Sean Conroy, Community
Development Director

Consideration of a request to amend Mapleton City Code section 18.82D.110 to increase the density in the Preserve project by 19 lots.

THE PRESERVE AT MAPLETON PLAT

THE PRESERVE AT MAPLETON PLAT
TRAIL EXHIBIT

Proposed Concept Plan

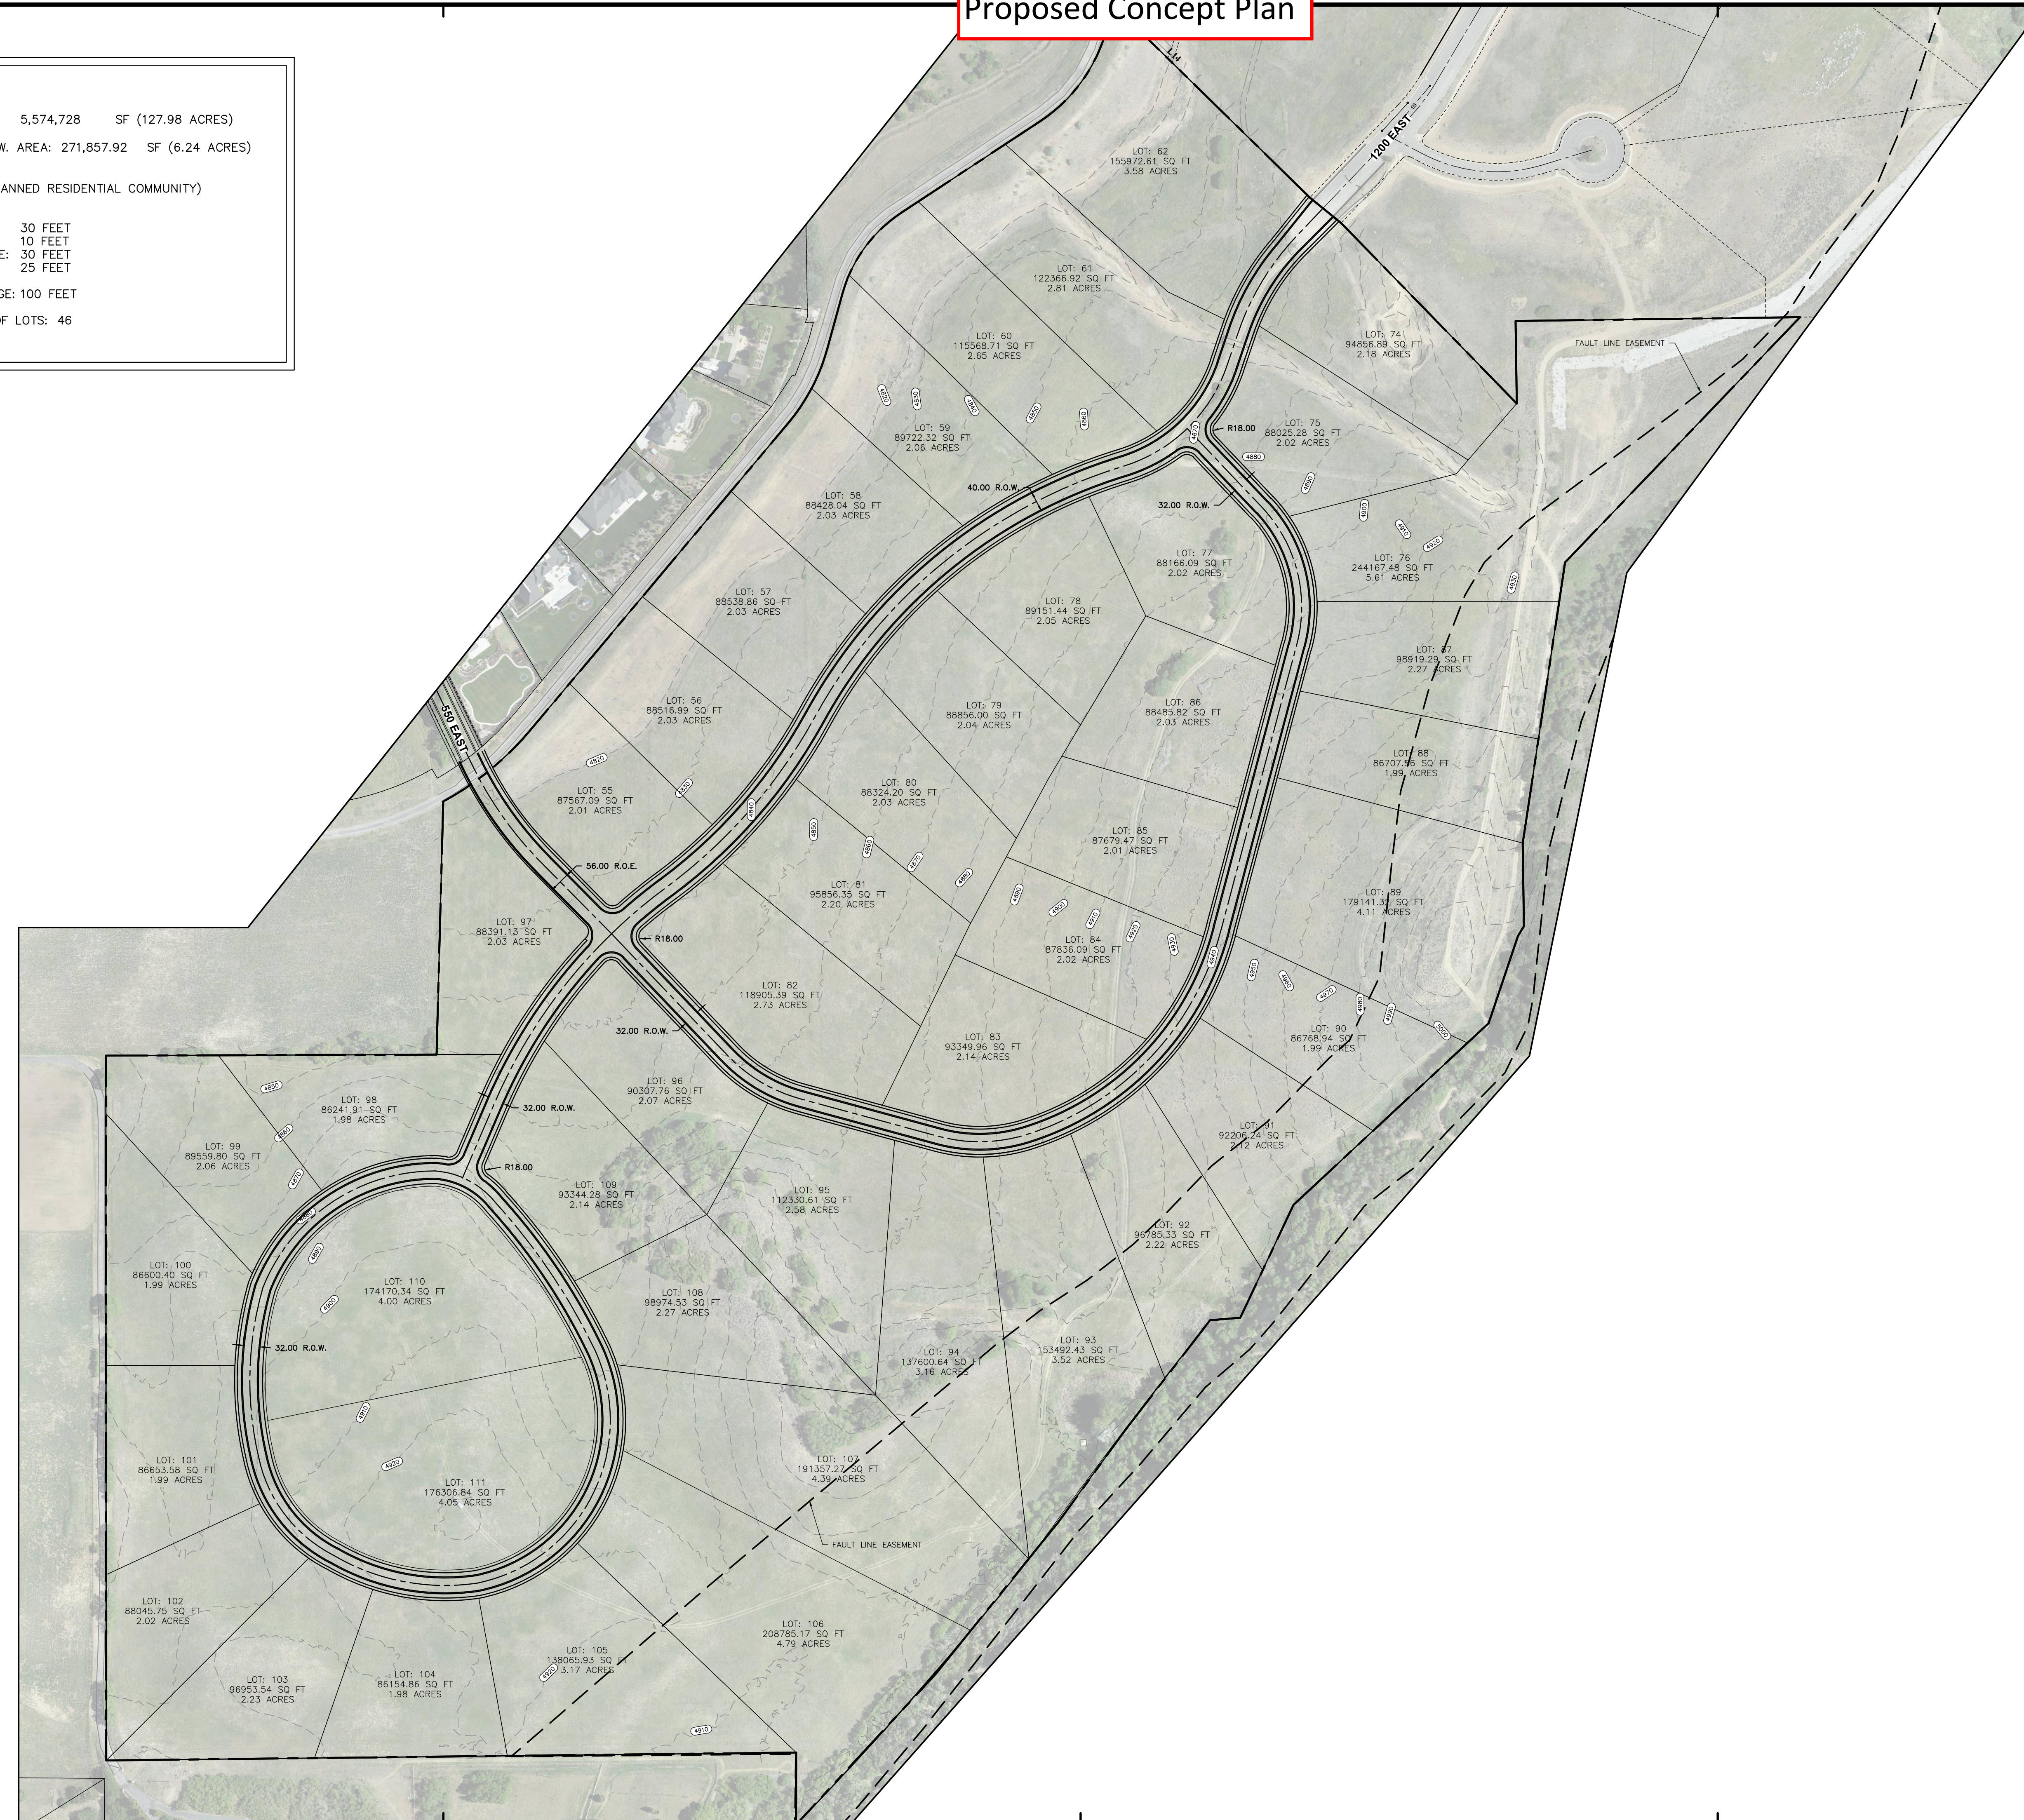
Density Comparisons: The average lot size of the original plats B and C was 4.1 acres per lot. With the revised concept plan the average lot size is still 2.6 acres per lot. While the density is increasing, and average lot size of 2.6 acres is still consistent with the goal of focusing on large lot development. All of the proposed lots that are adjacent to the existing developed lots along Perry Hollow Drive (Preserve Plat “F”) are at least two acres in size, which is consistent with the goal of ensuring compatibility between developments. It is also important to note that the last subdivision of more than two lots in the Rural Residential area that did not use TDRs to increase density was in 2000 (Horizon Heights Plat “B”).

The original concept plan included a stub road that extended to the southern boundary to connect with the Joyner property. None of the lots within the Preserve needed the proposed stub road for access, it was meant to provide access to the Joyner property and circulation for the area. The applicants have indicated that they do not want to provide the stub road as it provides no benefit to their project and it comes with a significant cost.

The Joyner property is approximately 40 acres in size. The Twin Hollow subdivision recently constructed a stub street near the southwest corner of the property. Since the subdivision ordinance allows for up to 30 homes on a single access road, it does not appear that a stub road from the Preserve would be necessary for the Joyner's property to develop. However, a stub road may still be desirable to provide a “convenient circulation system” and to avoid a dead-end street where one is not necessary.

One option that staff has discussed with both the applicant and the Joyners would be to require the applicant to grant an easement that would allow the Joyners, or future owners, to construction the stub road if it is needed in the future. The applicants are supportive of granting a permanent easement for the utilities but would like to have a sunset date on the roadway easement. If the stub road was not constructed within a specific time, say 10 to 15 years, the easement would expire. That would provide some finality to the owners of the lots that would be impacted by the easement, rather than having an open-ended potential of a road being constructed on their property. Staff would be supportive of this option.

1. The preliminary plat(s) submitted for the project shall be generally consistent with the layout

and configuration of the submitted concept plan.

2. The preliminary plat(s) shall include an easement to the Joyner property for future utilities and a possible street connection.
3. The proposed trail at the east end of 1600 South shall be constructed as part of the construction of the first plat recorded for this project.

Proposed Trail Plan

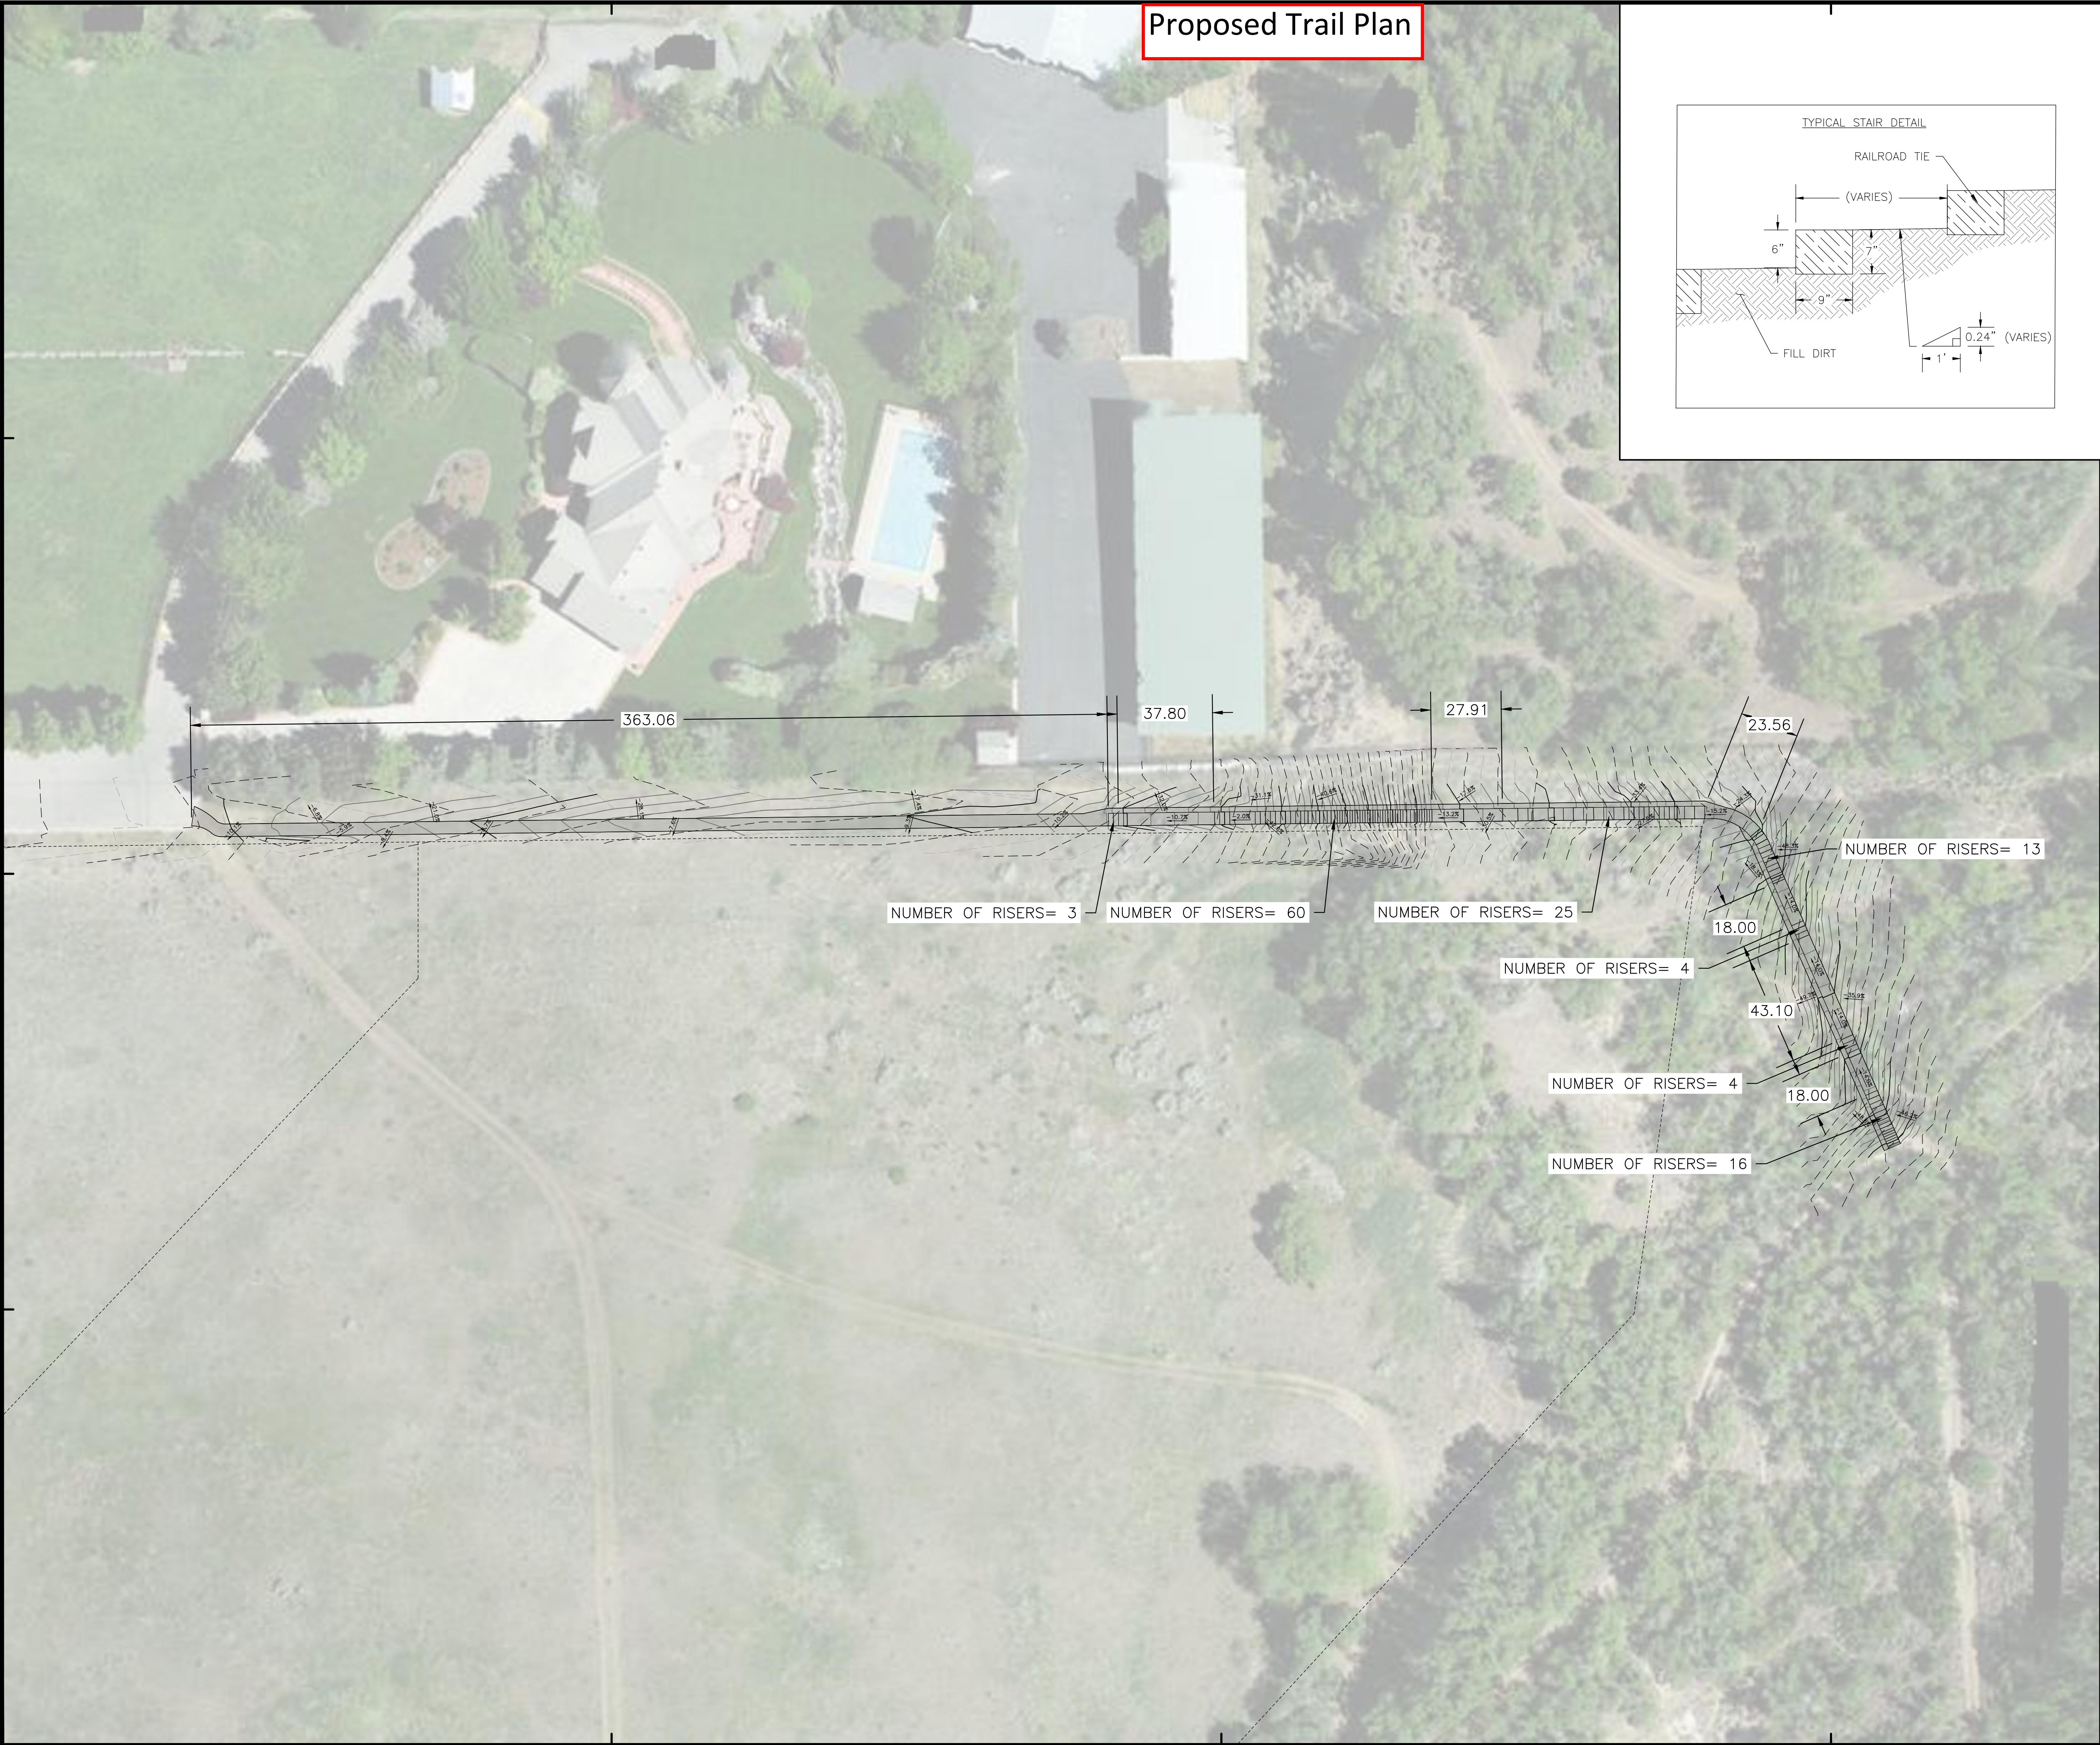
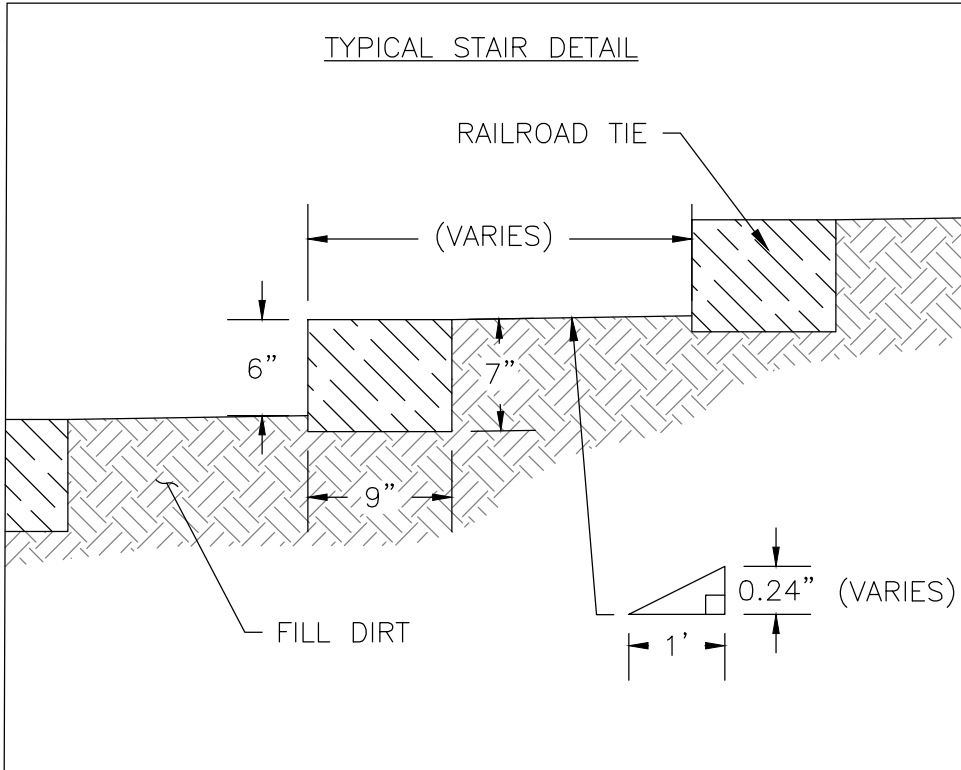
PRC-4 Zone: PRC zones are meant to allow for flexibility in lot sizes and to encourage imaginative designs. One of the key components of the original design that qualified it for a PRC-4 zone was the trail connection from the development to the Bonneville Shoreline trail on the bench above the project. The original plans included a trail connection within the area that is currently undeveloped. The applicant is proposing to relocate the trail to just north of the project on 1600 South, where the City owns property that leads up to the bench.

Much of the proposed trail alignment exceeds 30% slope. The applicant is proposing to construct stairs through the steepest portions to make access more feasible. Staff is supportive of the proposed trail relocation.
